First Solar FS Series Module Clip Compatibility

Compatibility of Jurchen Technology TP-MK-A 70 with FS Series Modules

Figure 1: Jurchen TP-MK-A 70 - X M / Middle Clamp

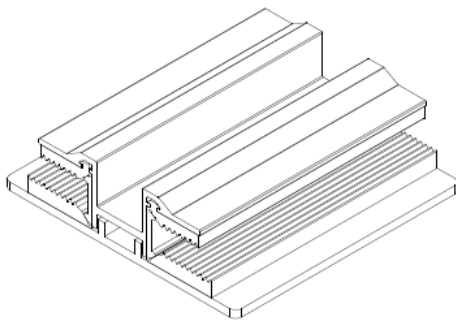
The Jurchen Technology TP-MK-A 70 in conjunction with FS Series module laminates has successfully met the First Solar mechanical load test. The proposed mounting clip design in conjunction with FS Series module laminates also meets the technical requirements concerning clip design that are specified in document PD-5-320 (see Figure 1 and Figure 2 below).

Clip Length: 70mm

Therefore, the Jurchen Technology TP-MK-A 70 in conjunction with FS Series module laminates is approved for use as long as the mounting system complies with First Solar's technical and mechanical requirements for mounting systems, as described in document PD-5-320.
